Office Action Summary

10/531,304

DETAILED ACTION

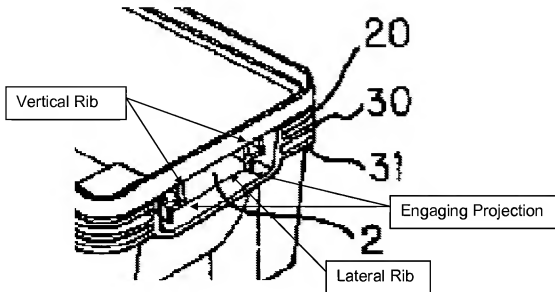
Claim 1: Ohori discloses a container comprising a container body 1, a container lid 2, a cassette 3, a cassette lid 8, an L-shaped flange 10, a first flange 20, and a second flange 30. Ohori further discloses a D-zone (portion with locking part 2), the D-zone having a lateral rib and two engaging projections provided on interconnecting vertical ribs (see below).

Ohori functions as claimed. Ohori lacks, or does not expressly disclose, vertical ribs between the first and second flanges, the specific distance between the first and second flanges, or the recessed D-zone.
